Consideration Of Resolution 2016-20, To Be Entitled: "A Resolution Approving A Development Plan For Epoch Development PUD Subdivision With 1 Modifications Of Development Standards (Parking Reduction), For The Property Located West Of Interstate 65, At 840 And 880 Oak Meadow Drive."

EPOCH DEVELOPMENT PUD SUBDIVISION, DEVELOPMENT PLAN
RESOLUTION 2016-20
FRANKLIN MUNICIPAL PLANNING COMMISSION
04/28/16

THE EPOCH DEVELOPMENT
PUD SUBDIVISION, DEVELOPMENT PLAN
COF #6086
FRANKLIN, TN

C0.0
COVER SHEET

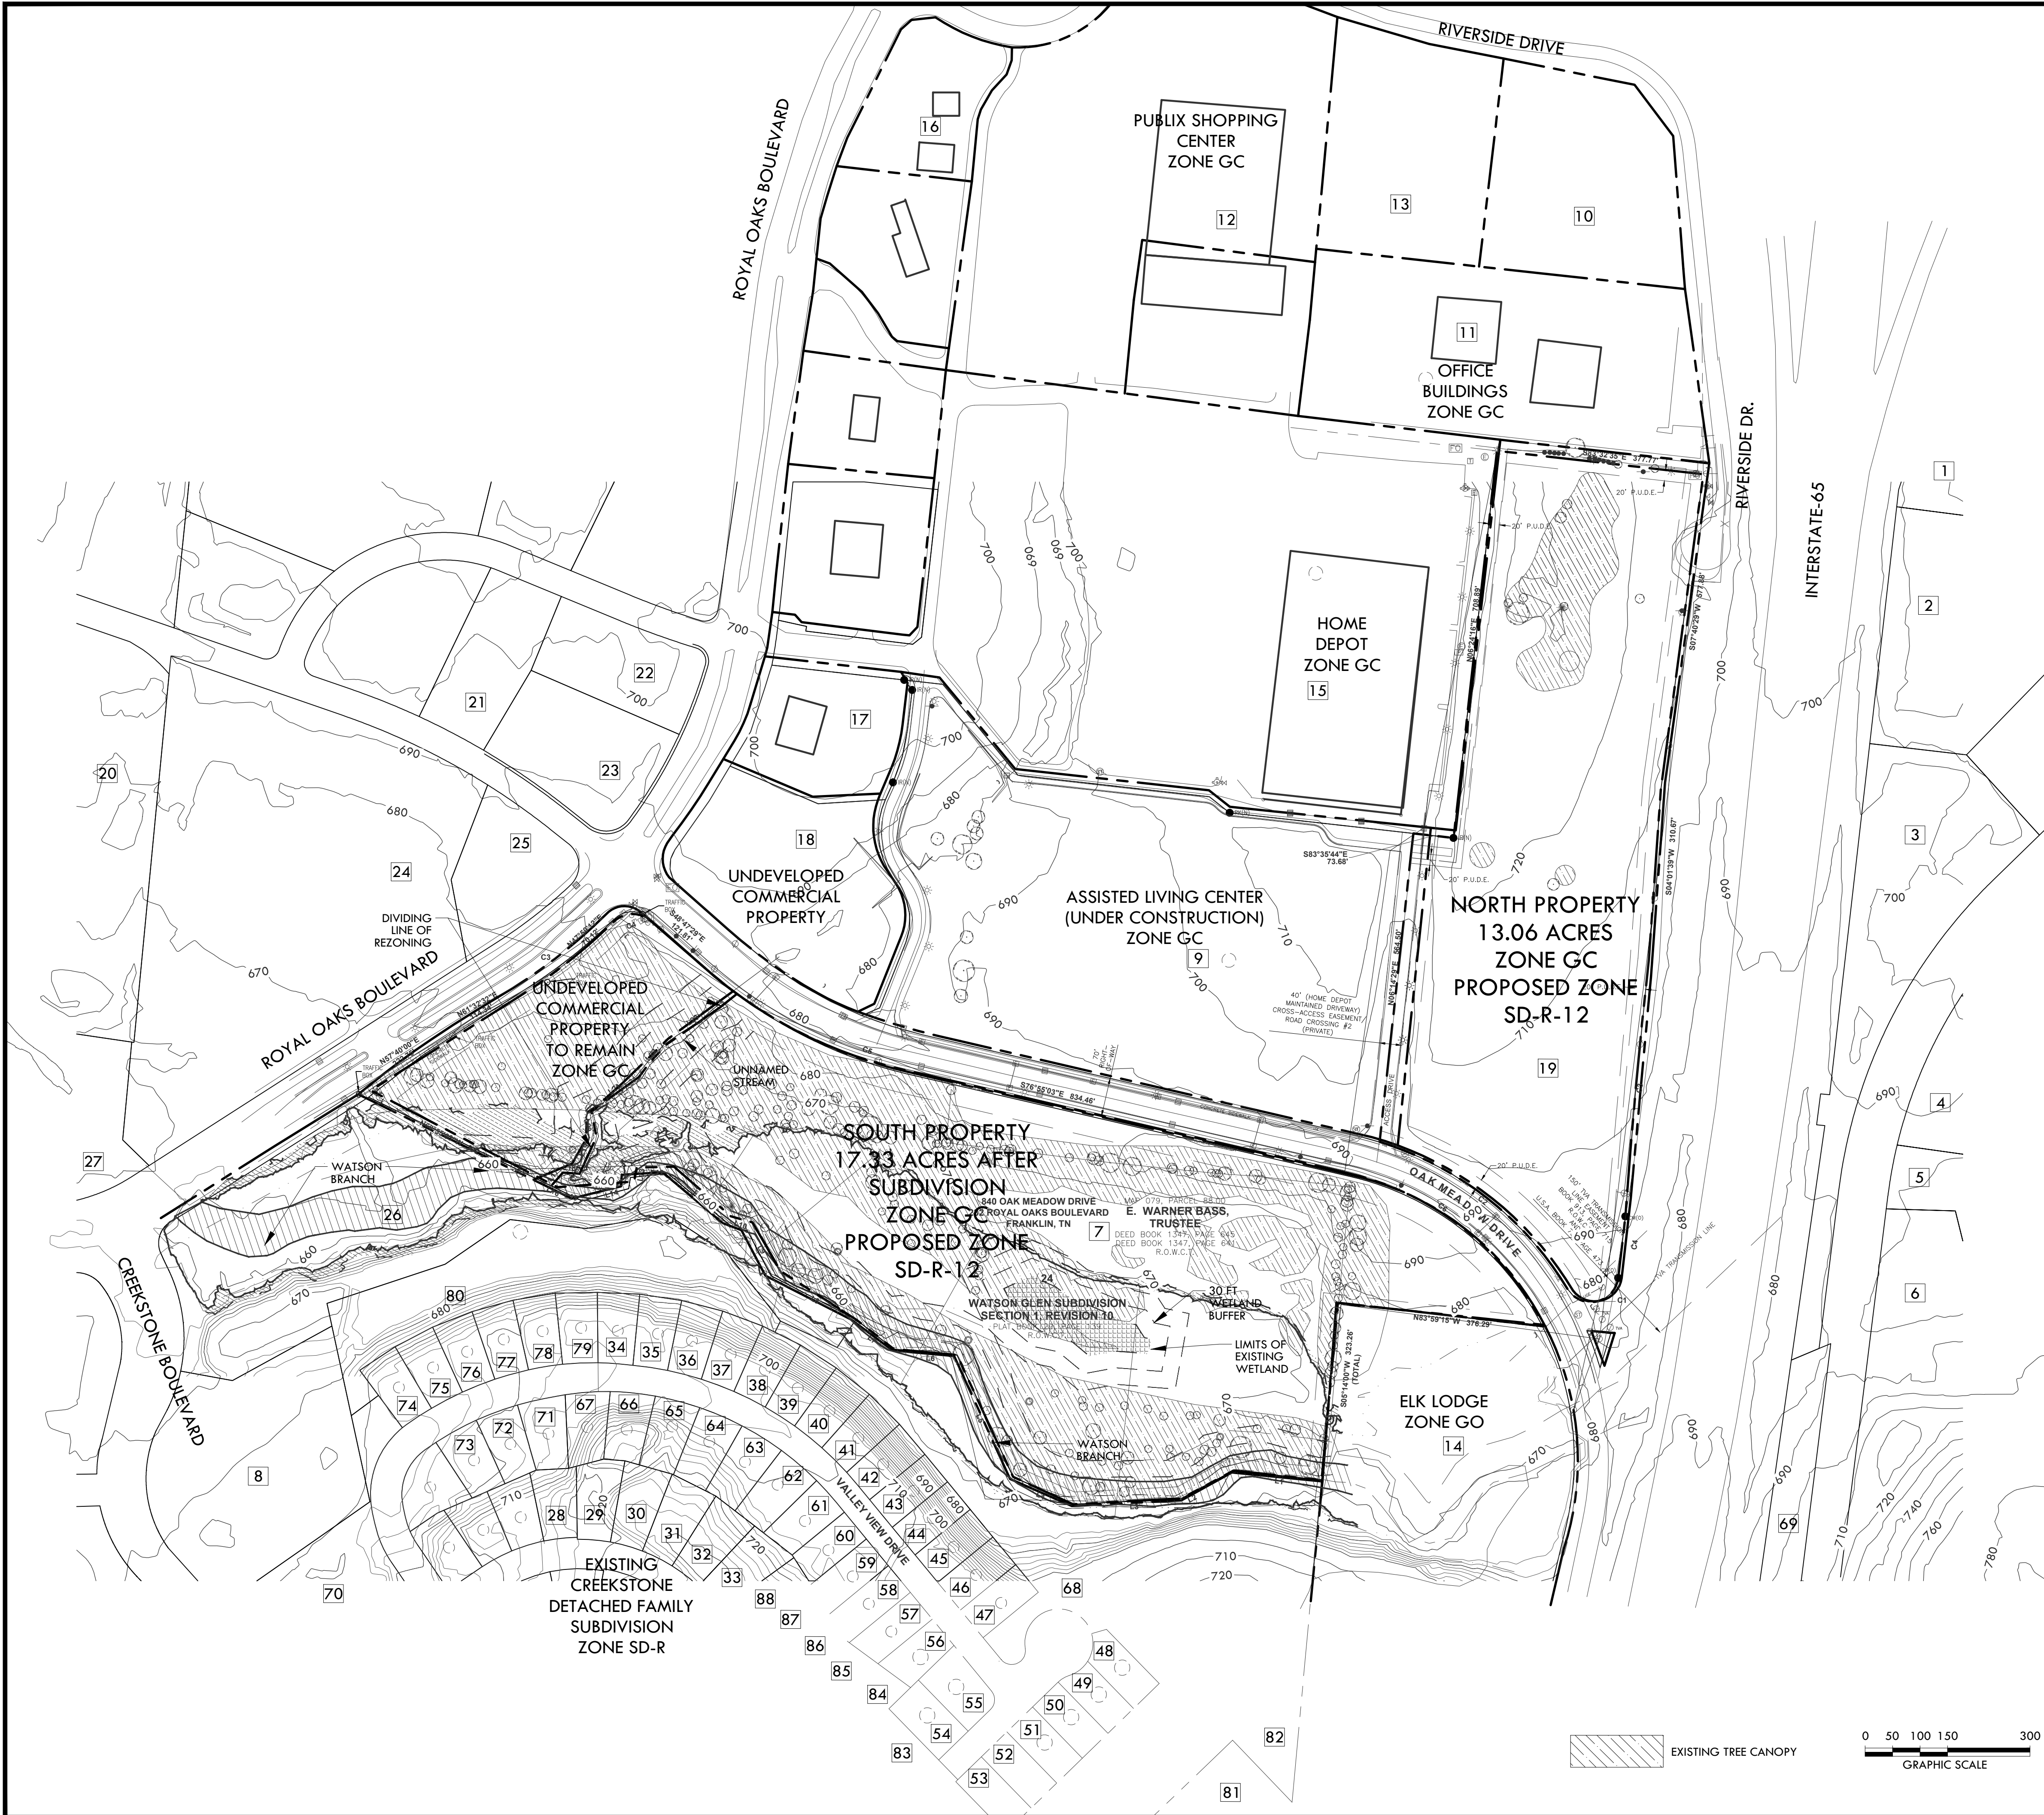
10. Cover sheet

- The applicant shall add sheet numbers to all architectural elevation sheets.

C3.0
OVERALL
GRADING
PLAN

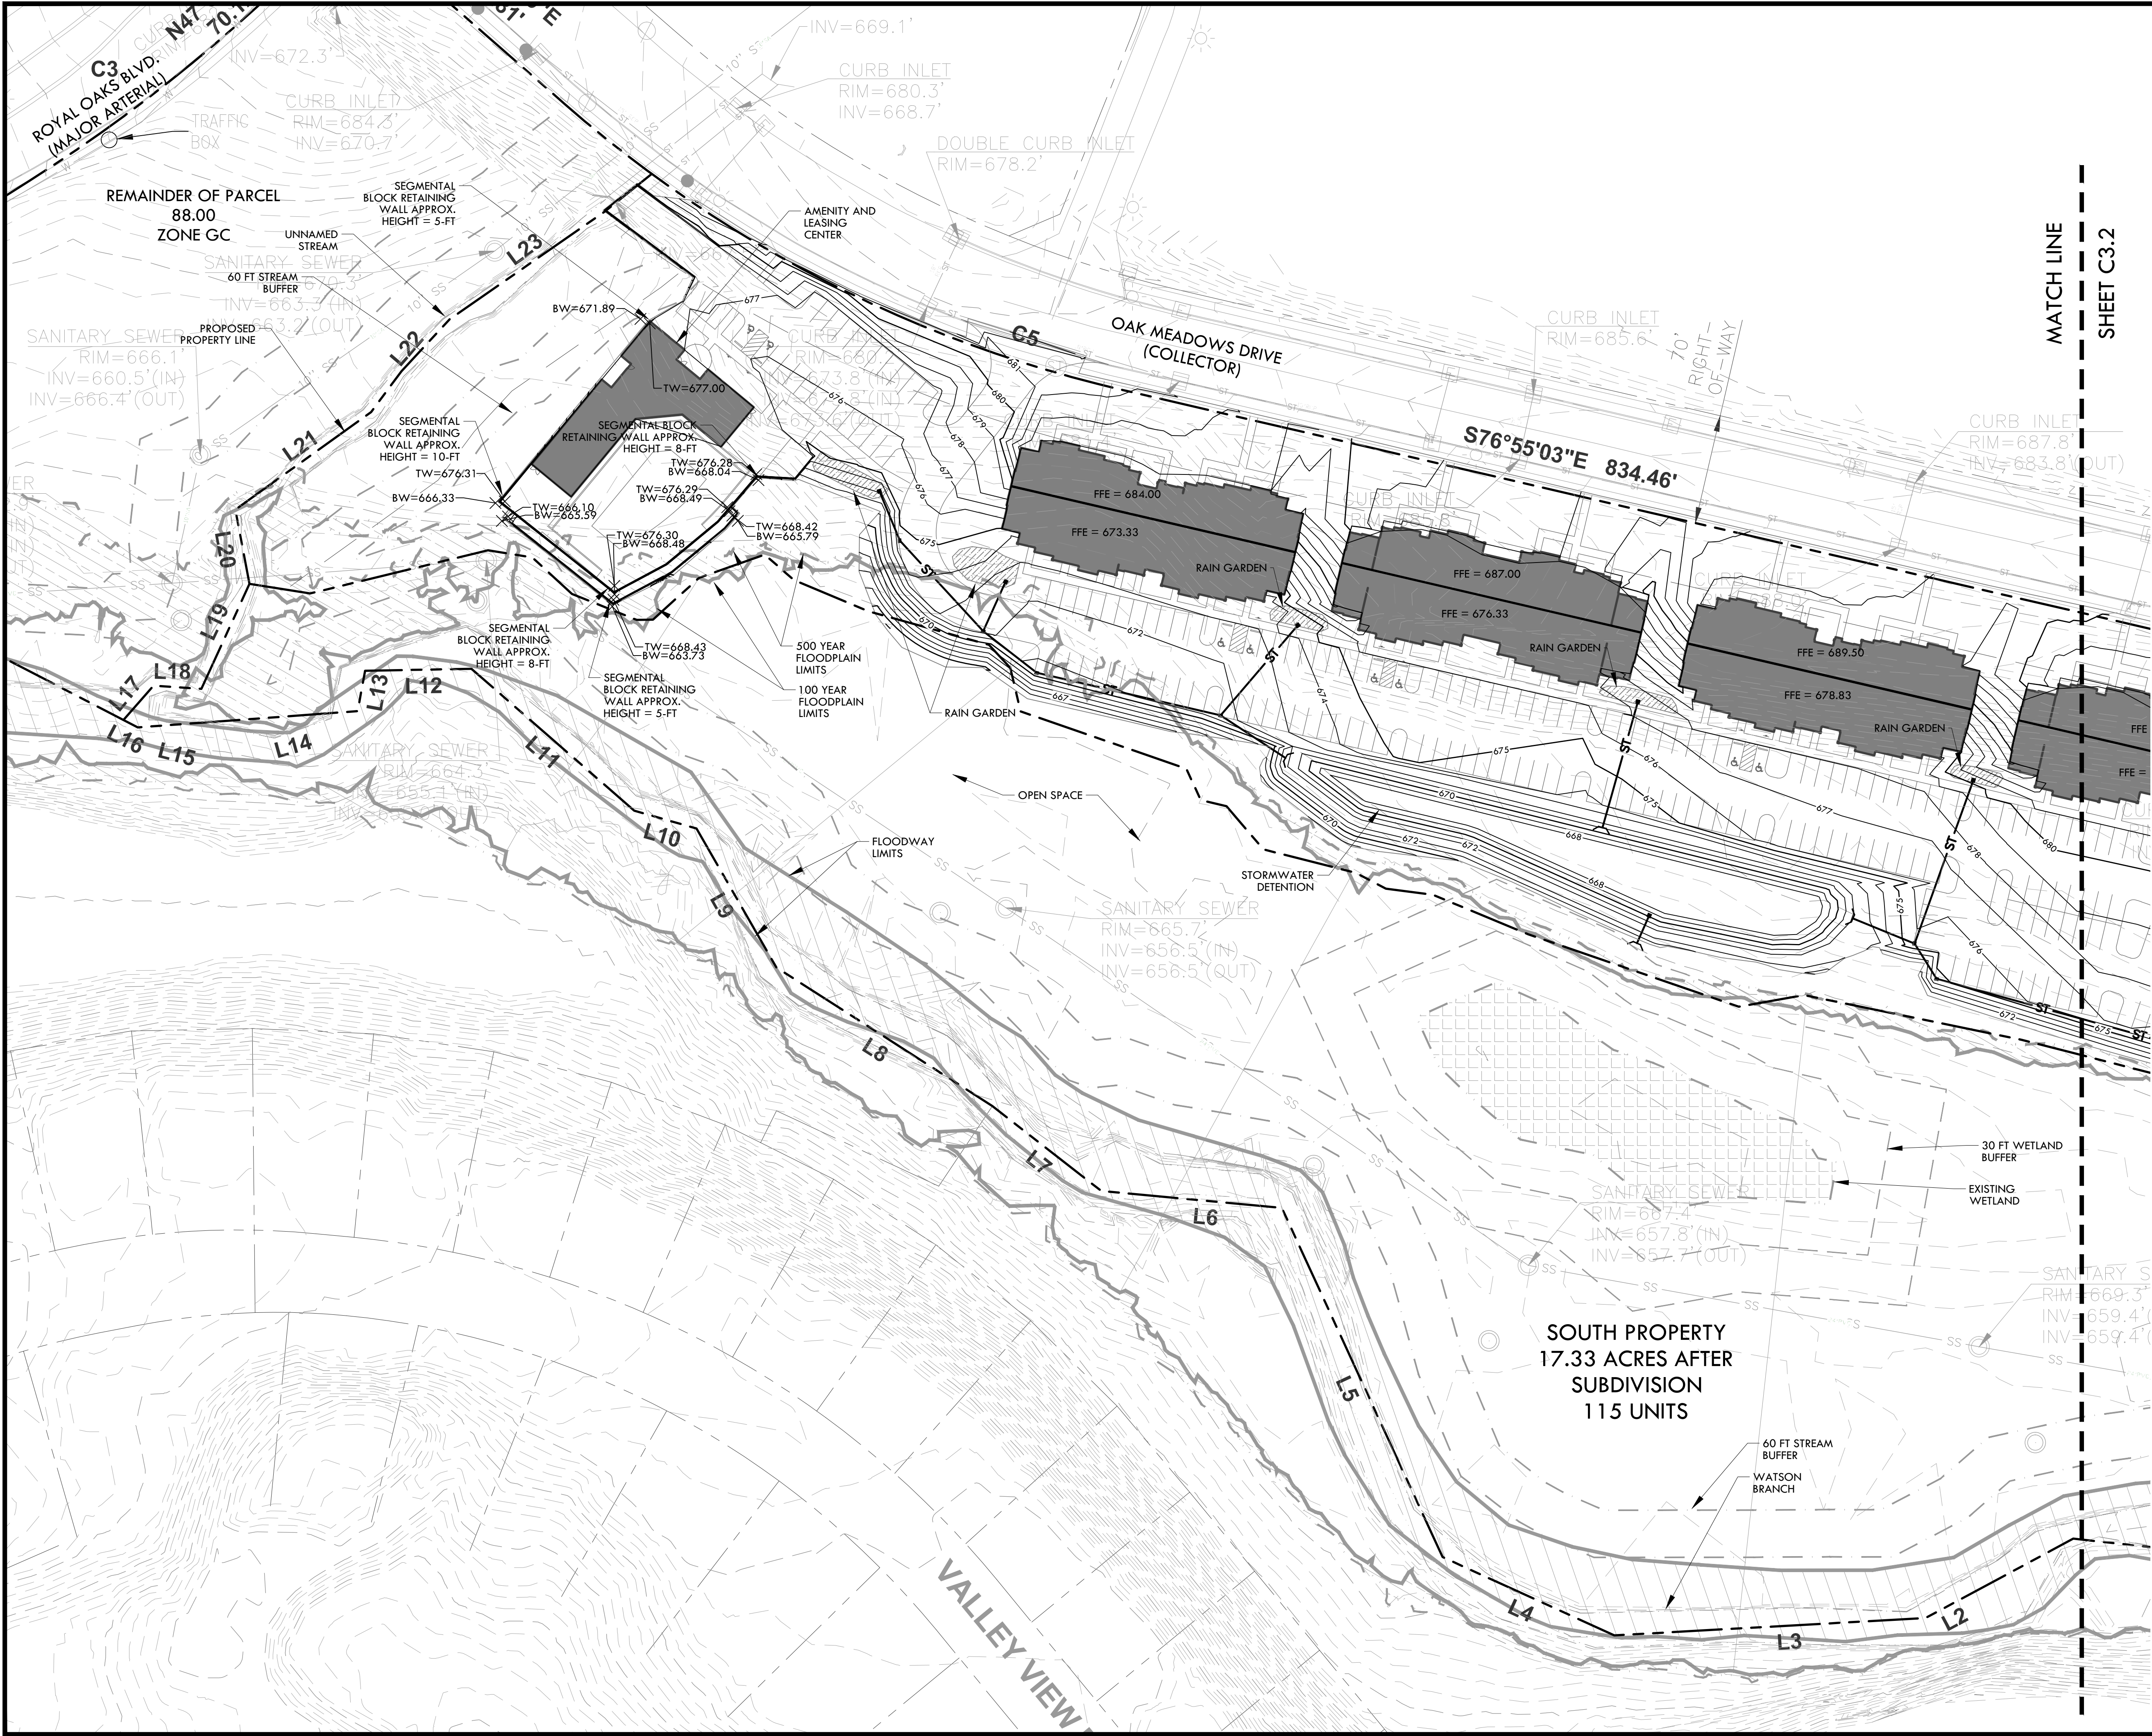
1. C3.0 - Overall Grading & Drainage Plan

- The grading plan has changed since the previous submittal. These issues must be addressed. A sewer manhole is indicated at the southern property corner of the northern section. A storm drainage headwall and pipe are in close proximity of the manhole. The headwall must be located outside of any sewer easement. Provide the discharge point and the swale or grassy area for the swimming pool discharge. Swimming pool backwash is not permitted to flow into the sewer system or any bioretention or stormwater quality area. Provide the capacity of the downstream stormwater pipes and structures.

C5.0
OVERALL
UTILITY
PLAN

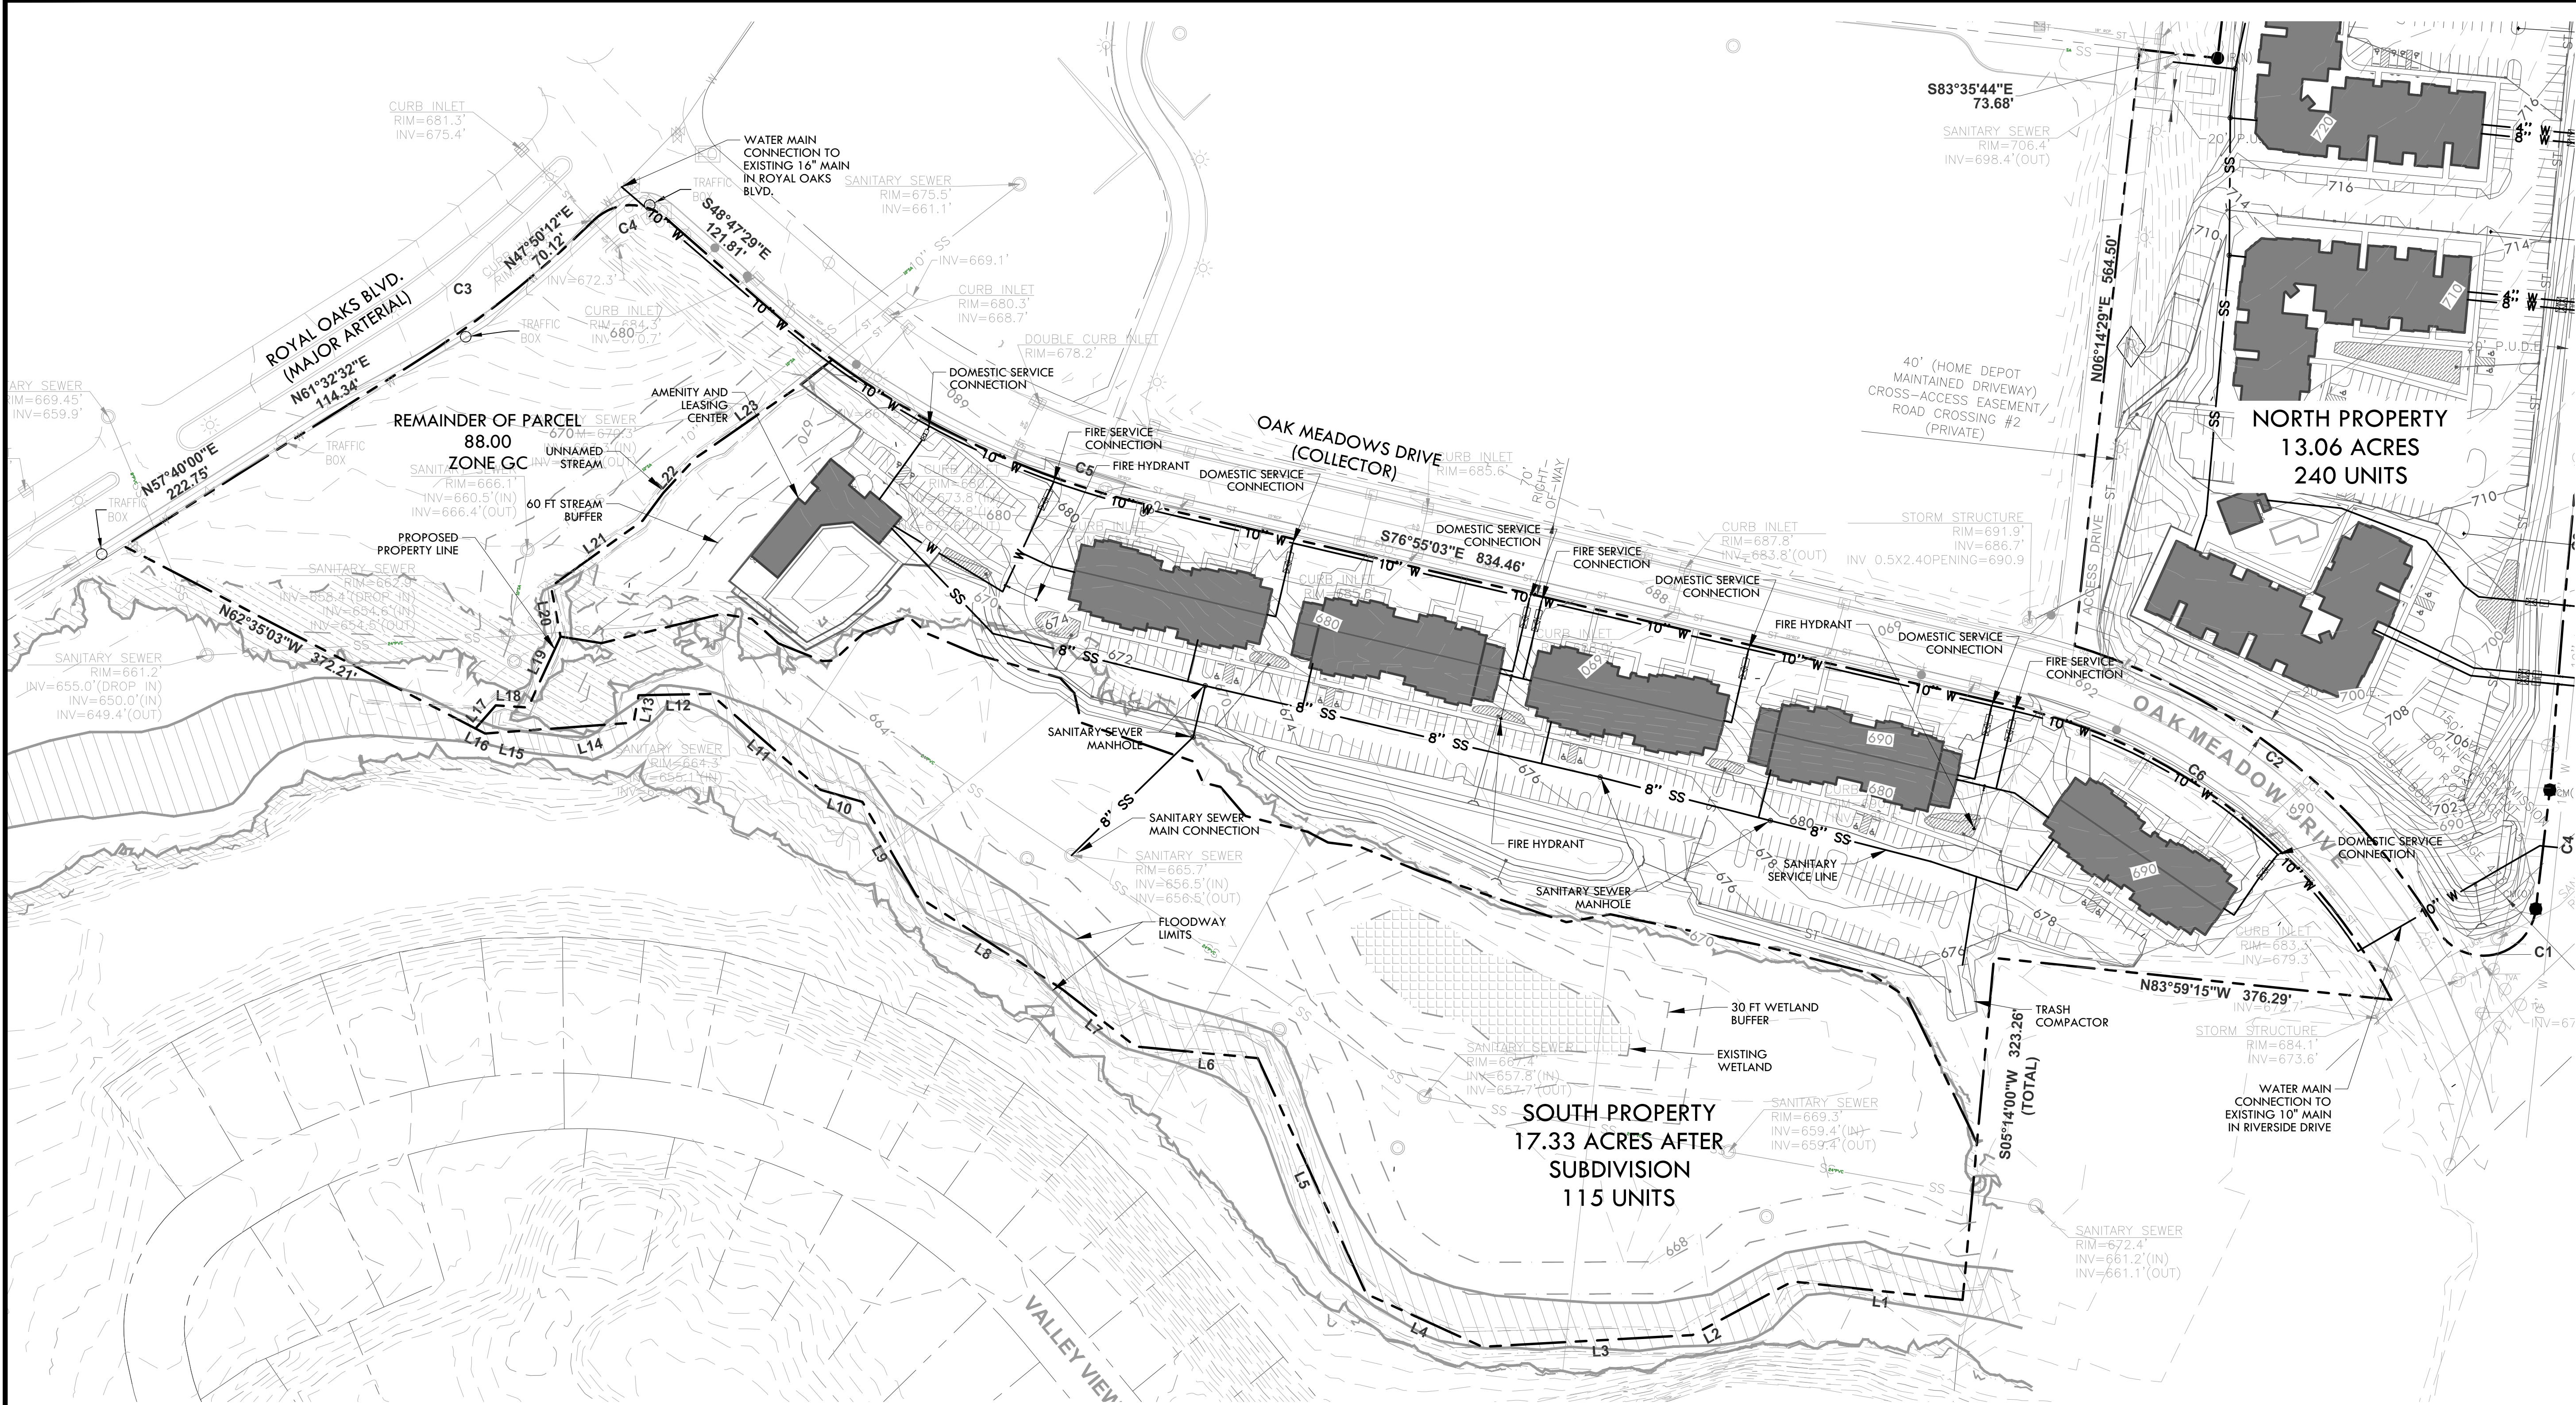
3. I. Utility Plan

- The reply to the previous issue "Clearly label locations of any trash compactors on the utility plan. Trash compactors must be covered and connected to the sewer system with the proper separator." brings about the following issue. The sewer service line that serves the maintenance building must be a separate service line from the line that serves the compactor. Sewer service lines must serve one building only. An 8" sewer line must be extended to the end service line.
